Product Change Notification

Change Notification #: 115548 - 00
Change Title: Intel® Dual Band Wireless-AC 7260 for Desktop, SKU 7260HMWDTX1.R, PCN 115548-00, Label, Label Update
Date of Publication: May 26, 2017

Image 1:

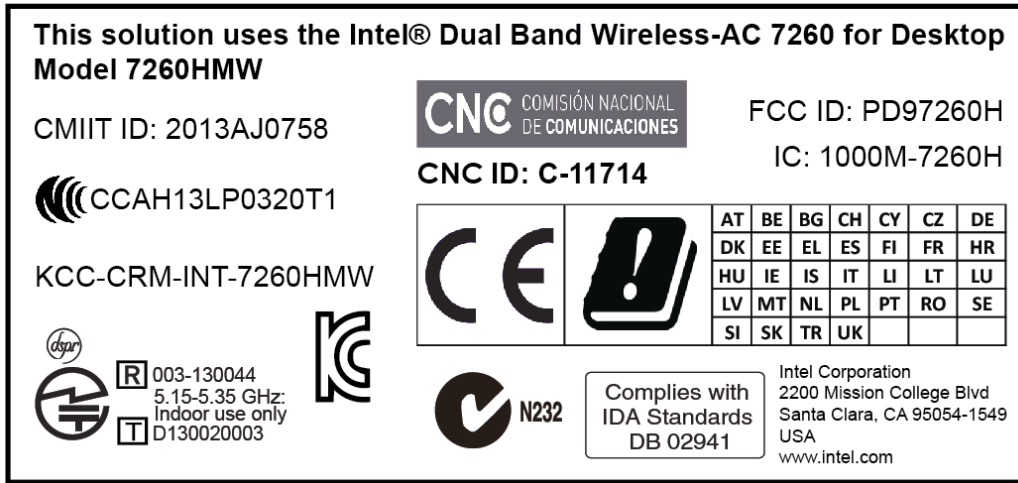
- The current CE ! Mark on the module will be modified to remove the Alert Symbol (!) following the CE mark.

In the case of this Desktop kit, we are adding a label to cover the old markings and replace with new updated markings printed on the label.

The box outlined in red shown in image 1, will be replaced with a label as shown in image 2.
